## Lexington Avenue Solar Project Public Hearing Comment and Response Matrix

On November 16, 2020, the Planning Board received a letter from George and Madeline Fouhy with comments regarding the proposed Lexington Avenue Solar Farm. This matrix summarizes and provides responses to each comment included. Comments have been lightly edited for brevity. The original letter provided to the Town has been included as an attachment to this document.

Attachment A – Letter from George and Madeline Fouhy to the Town of Cortlandt  
Planning Board, dated November 16, 2020

**(See Mohegan Lake Quadrangle US Geological Survey Map next page)**

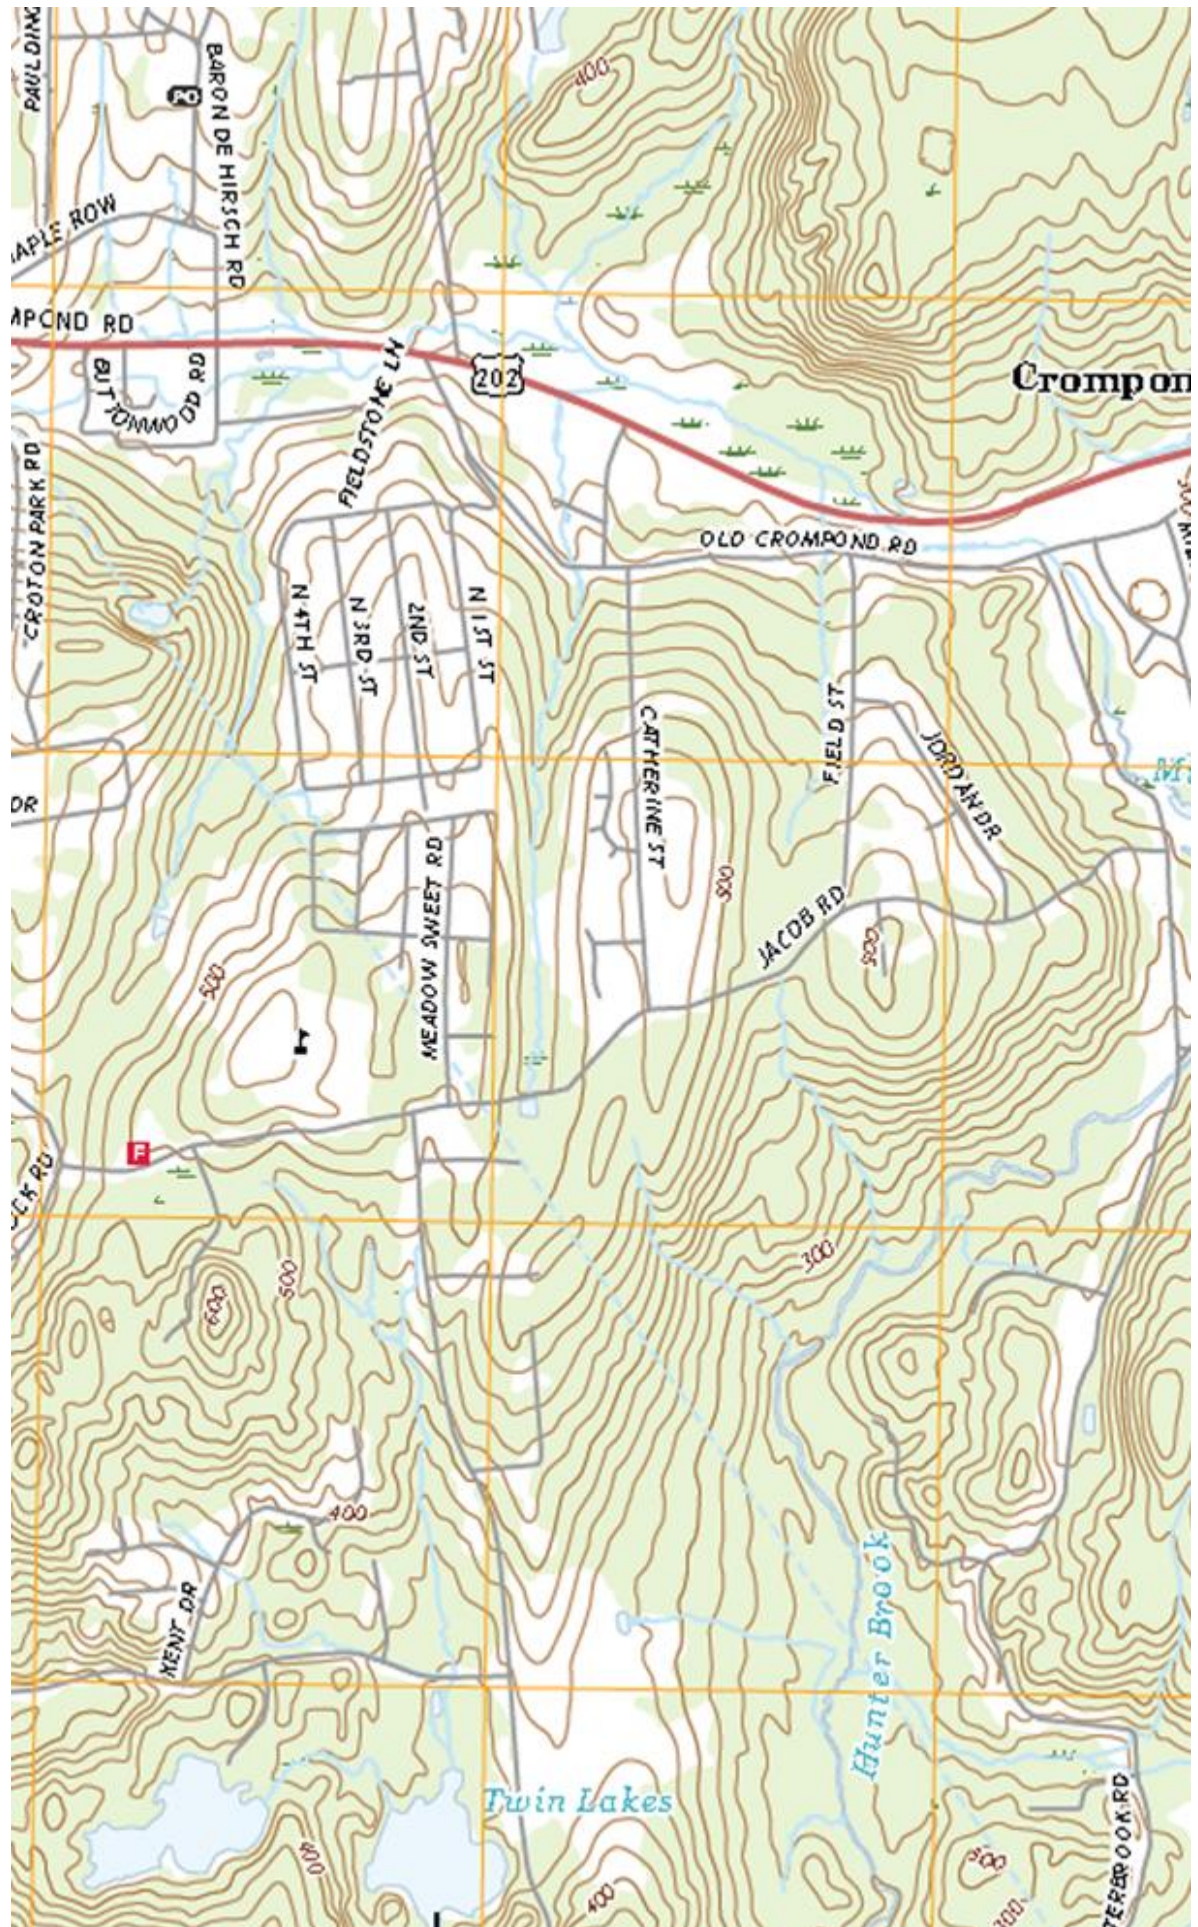
The land behind the residential properties on Baron De Hirsch Rd. slopes down to a stream and up on the other side of the stream to Lexington Ave. The slope varies I would say between 20 and 30 degrees (or between 15% and 45%, not 20% and 30% on the site plan). The stream flows north and south and the slopes are east to west and down to the south. Once on the other side of the stream near the solar panels, the slope becomes even greater. When you are in the Solar Farm area the slope is more north to south and the slope descends steeply to the wetlands. (Drive down Lexington Ave. from Dykeman Dr. to Rt. 202 for an idea of the slope. Better yet, try walking up Lexington. Bring some oxygen.) I walked part of the area. I did not use a google map as the Dimension Site Plan says it did. I believe my estimates are better than the Dimension Energy Site Plan. I believe this Solar Farm will need extensive excavation and possible retaining walls to work at all.

At the October Planning Board meeting, the company's representative did not commit to building the access road shown on the site plan. He seemed to indicate they wanted to use Dykeman Dr. for access.
